FROM STA. 40+39	TO STA. 40+94.50
PROJECT NAME	MONTPELIER
NO. M66C-M6400 (7)	PLOTTED 05/04/87
SURVEYED BY	KASTNER-MOREAU 06/85
SHEET 202 OF 335	SHEETS

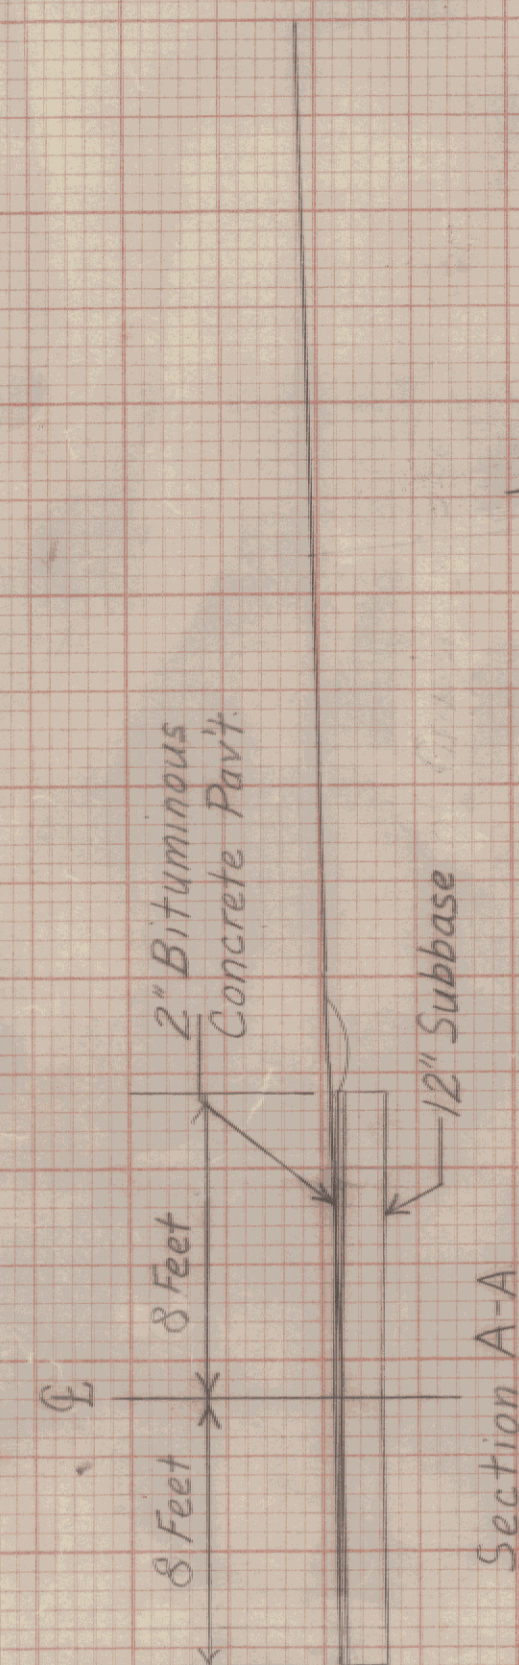
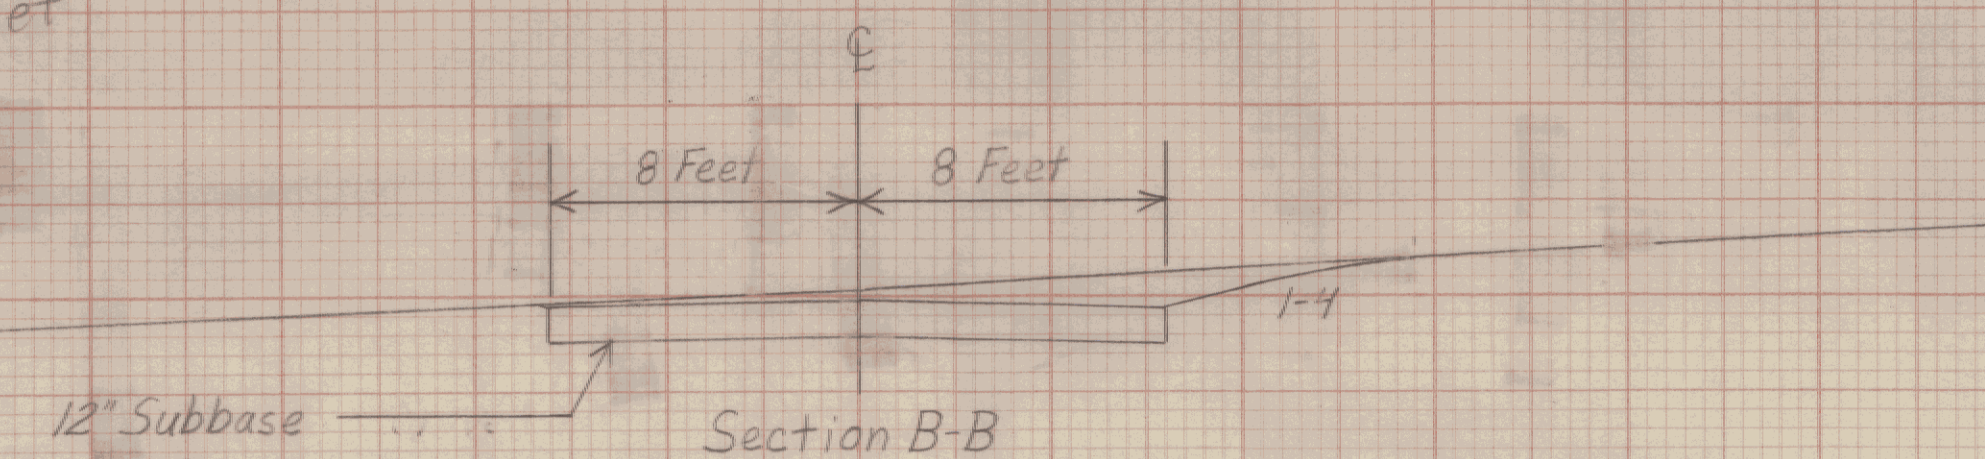
Note: The tree @ 40+93L and the Bush @ 40+95L are to be transplanted outside of the R.O.W. limits in a location of mutual agreement with the property owner and the resident engineer.

Rev 40+98L
End Portland Cement Concrete Sidewalk, 5' 5" wide

Rev 40+95L ~ Wheelock St. 25+59L.
Exist. 12" CSP and DI - Retain Change Elev. of DI.

Rev. 40+95L ~ 41+84L
New 24" x 94" PCCSP .064 or CAAP .060

Rev. 40+95L
New 24" x 4" CSP .064

Rev. 40+97L
Construct Sidewalk Ramp (Type I)

40+95L ~ 41+45R
New 36" x 106" PCCSP (PI) .079 OR
CAAP .075 w/ Stone Fill, Type I @ Inlet
(See details on Sheet 203)

Rev 40+90L
End Vertical Granite Curb

Rev 40+50L
End New 18" x 160" PCCSP .064 or CAAP .060

Rev. 40+48L
Begin Vertical Granite Curb

Rev. 40+39L
Construct Drive 16' Wide (Paved)

Rev. 40+26L
End Vertical Granite Curb

40+94.50
Rev. 40+94.24
40+95E Remove Existing 24" CMP, RCDI and Stone Headwall

Rev. 40+50L ~ Rev. 40+67R
New 18" x 34" PCCSP .064 or CAAP .060

Rev. 40+90R
End New 6" x 330" Underdrain w/ Flushing Basin @ 40+90R
Rev. 40+62R
Begin Vertical Granite Curb

Rev. 40+55R
Construct Drive 16' Wide (Gravel)

Rev. 40+46R
End Vertical Granite Curb
